6400 BROOKVILLE ROAD, CHEVY CHASE
[APC CASE # 55/13-1300]
CHEVY CHASE H.D.

SUBJECT: Historic Area Work Permit #637227, additions and alterations to house

PROPOSAL: Additions and alterations to house

HPC Preliminary Review Submission

EXISTING RIGHT ELEVATION

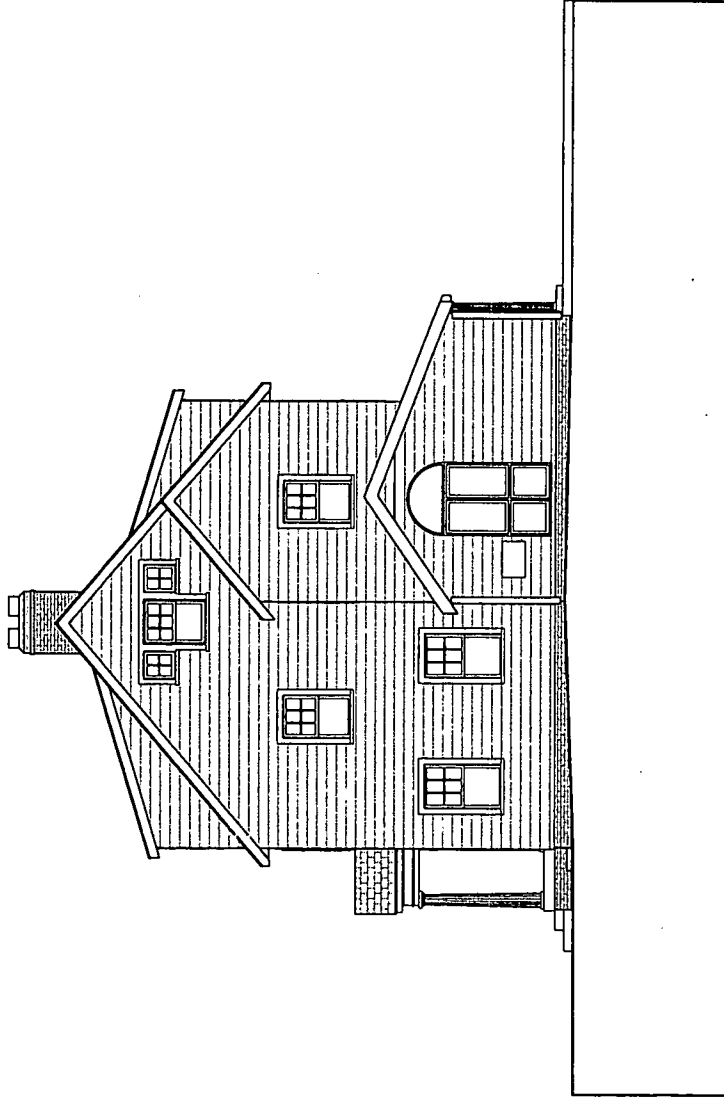
18 Everything that needs to be discussed tonight
19 should focus on the right elevation mud room that's going to
20 replace this addition over here. The Commission reviewed
21 this in front of me back in May and they were very
22 supportive of all of the elements, including a new, a
23 removal of the non-historic addition, construction of a 1-
24 story addition and some alterations on the left side, some
25 window changes, as well as materials.

9 The HPC's main concern with the first proposal was
10 about the massing and the detail of the proposed right side
11 elevation mud room addition. Notably, they found the height
12 in the detailed mud room as being too predominate and
13 recommended that the scale and design be simplified. HPC
14 provided some recommendations to the applicants that
15 included doing a flat roof that would be similar in design
16 to the left side mud room or excuse me, rather, entrance or
17 doing a gable in a siding treatment. There was a majority
18 from my read of the transcript of the HPC that stated a
19 simplified, flat roof design would be more complimentary to
20 that design and massing of the proposed left side covered
21 entry feature.

21 MR. RODRIGUEZ: And you look at the elevation, you
22 don't have an overhang on that side of the roof and I think
23 that's a detail that's a little bit strange and that would
24 be my only comment.

4 MR. RODRIGUEZ: Yes, but if you look at your
5 elevation, you will see that what you have drawn, it's not
6 that, and even normally you are, the overhang, the roof line
7 starts moving closer to the house. It's something, it's a
8 detail, but I think it's worth it that you look at that
9 carefully.

22 We then decided to try a different approach to the
23 mud room roof, again with the goal of simplifying the mud
24 room design in response to the Commission's comments. Anne
25 changed the slope of the mud room roof so that it would

1 match the slope of the roof on the existing house and the
2 proposed addition.

3 To keep the massing small, we lowered the eave
4 height of the mud room. We also followed Mr. Rodriguez and
5 Mr. Kirwan's suggestion that we, quote, "Tone down," the mud
6 room somewhat by replacing the mud room siding material that
7 had been paneling and pilasters to siding. And I can't
8 remember, one of the commissioners also somewhat took issue
9 with the little lantern that was hanging and we killed the
10 lantern too. So Option B, which begins at page 32 in your
11 packet, reflects all of these changes.

6 MS. DECKER: -- on, excuse me, on Option B, we did
7 increase the pitch of the roof, although it's a little bit
8 more humble in that it's sheaved in siding to meld with the
9 rest of the addition. That roof line, though, is steeper,
10 but we've lowered the eave by 12 inches. So it's, again,
11 reduced in overall wall height, at least for the spring
12 line. And in terms of the increase of, as Andrea was
13 saying, that we wanted a little bit more wiggle room to
14 complete the trim on the interior and we're just very tight
15 on the mudroom space.

16 And so what we've done here was increase the width
17 of the mud room two inches either side because it's centered
18 about the gable, which is kissing the edge of the tower. So
19 we can't, that kind of sets the hinge point. So it's four
20 inches total width and six inches towards the driveway.
